ASI-12

Project: DelDOT Georgetown Administration Building

Project No: T202180102

1 FIRST FLOOR SANITARY PLAN
P-101 1/8" = 1'-0"

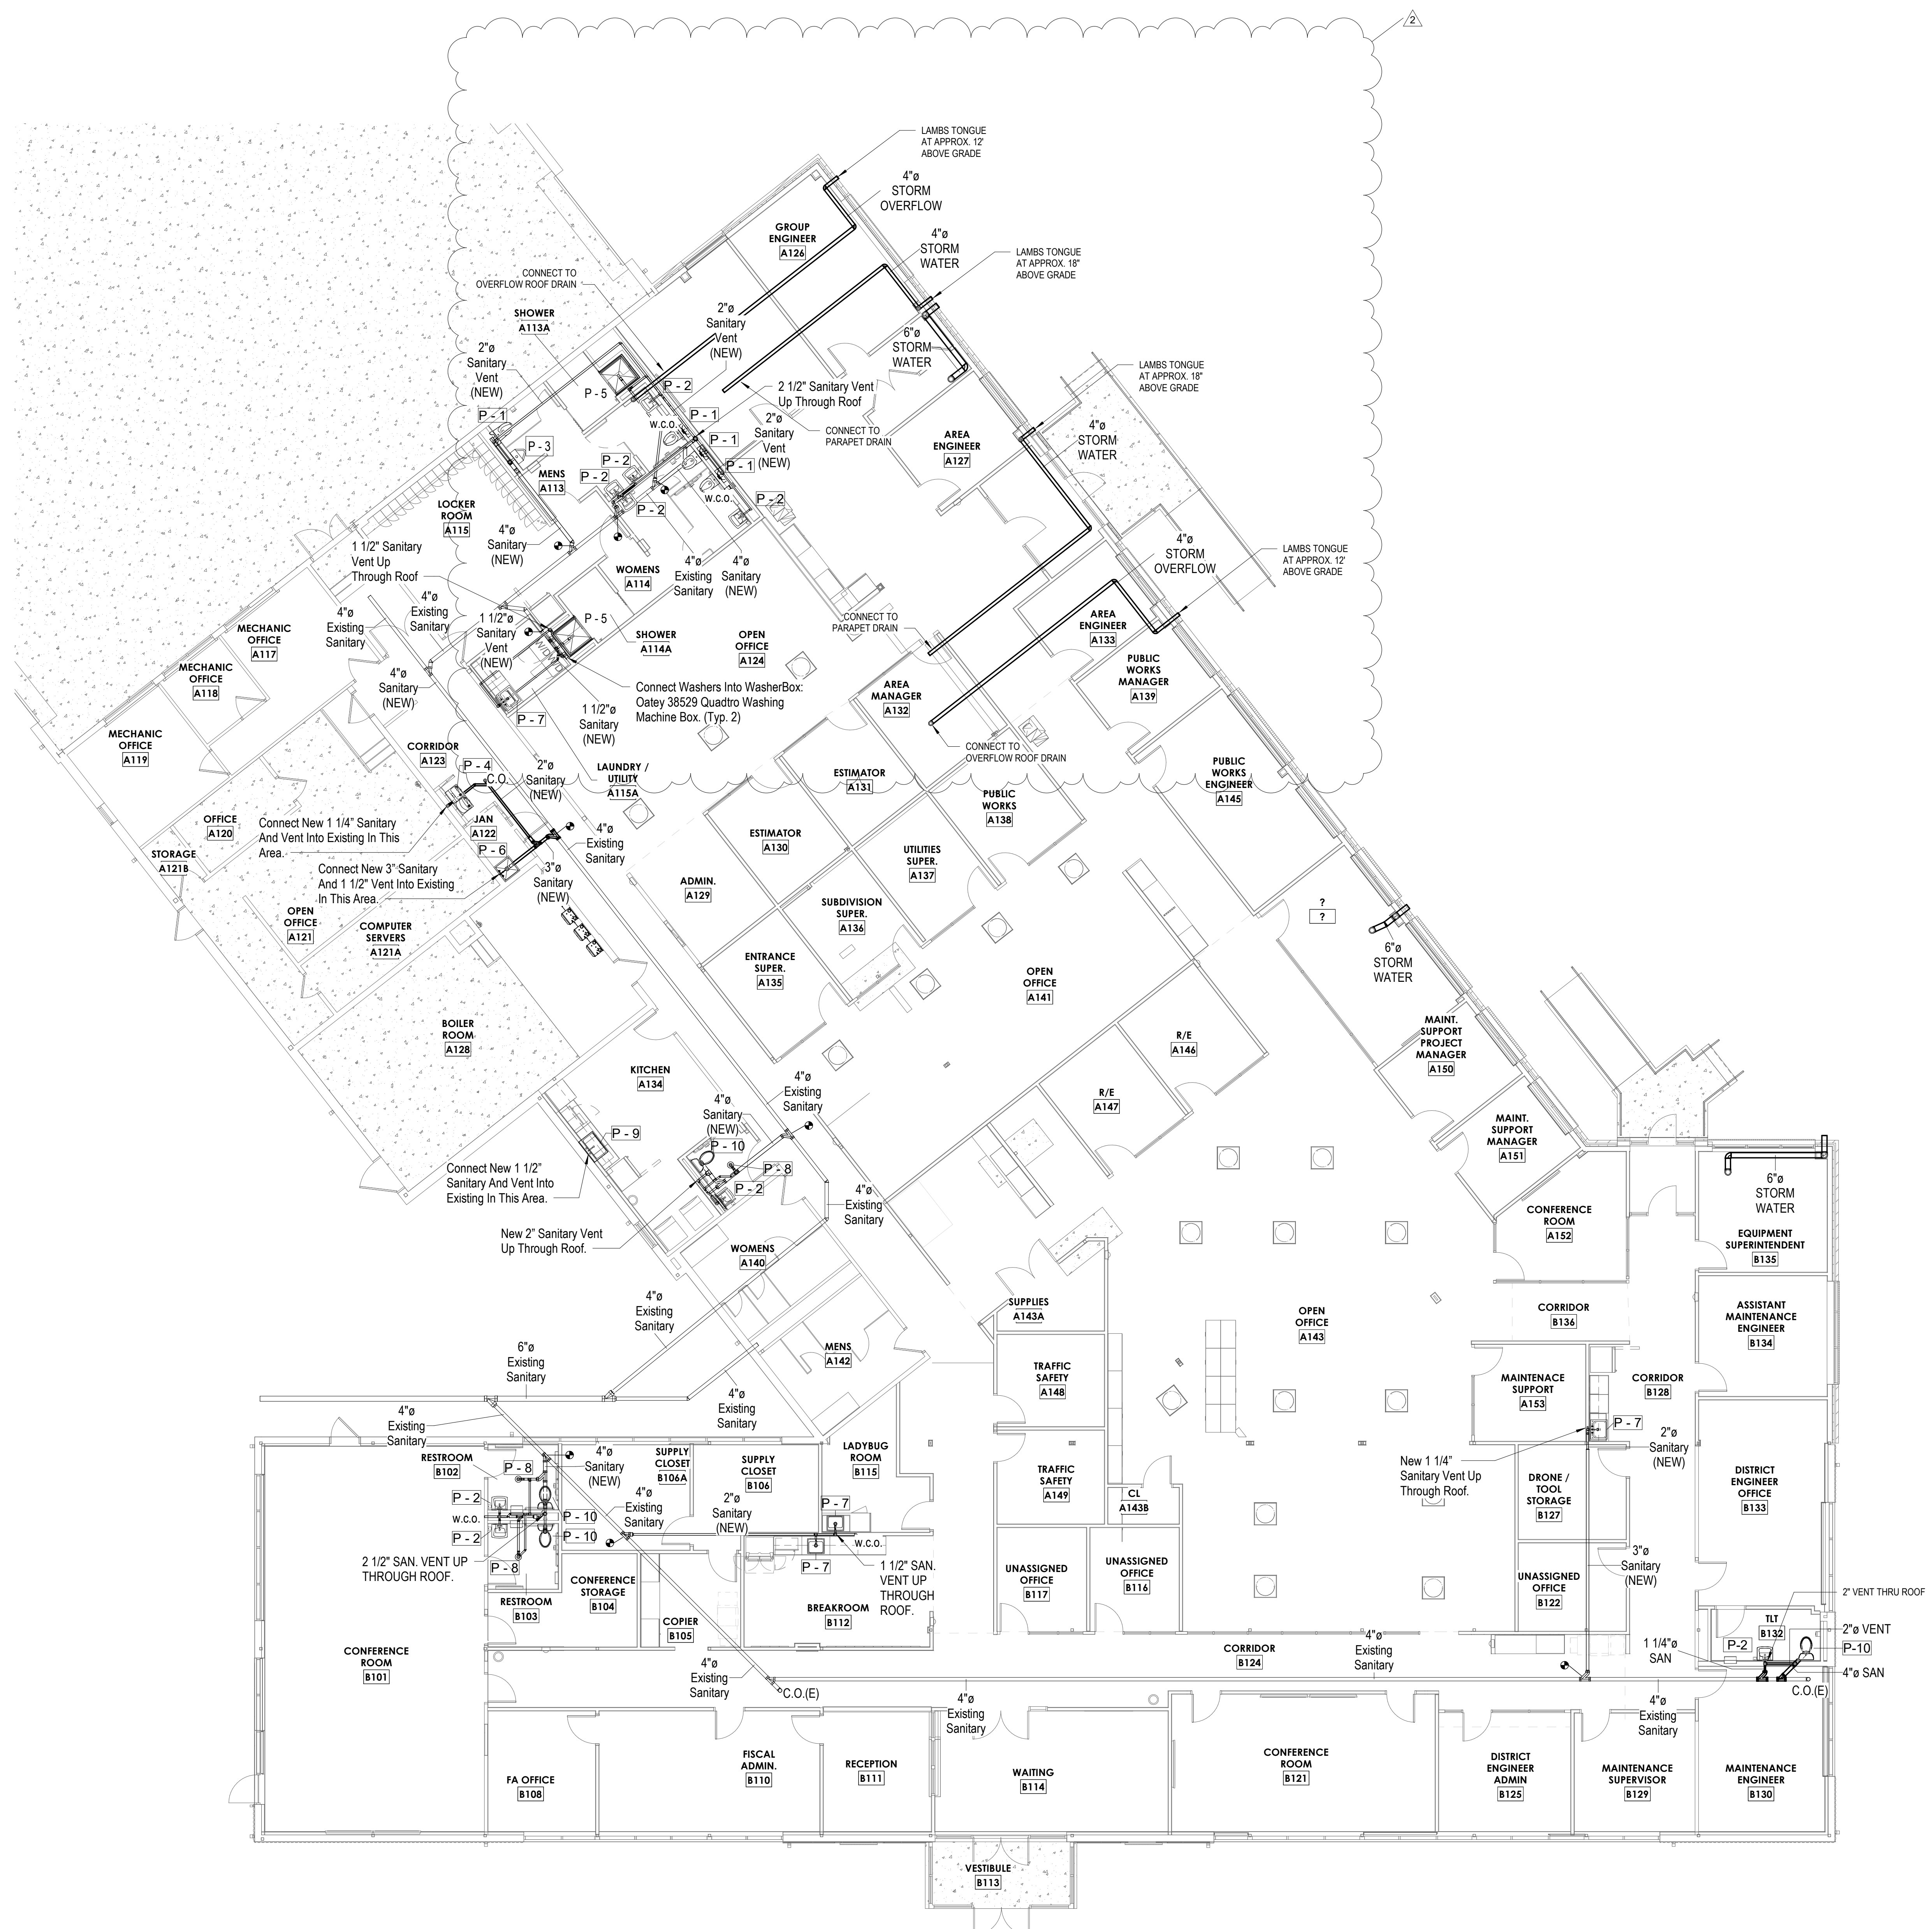
1. Delete two (2) overflow scupper drains and provide two (2) overflow roof drains as described in attached drawing.
2. See attached updated Drawings P-101 and P-103.
3. Provide cost proposal for approval.
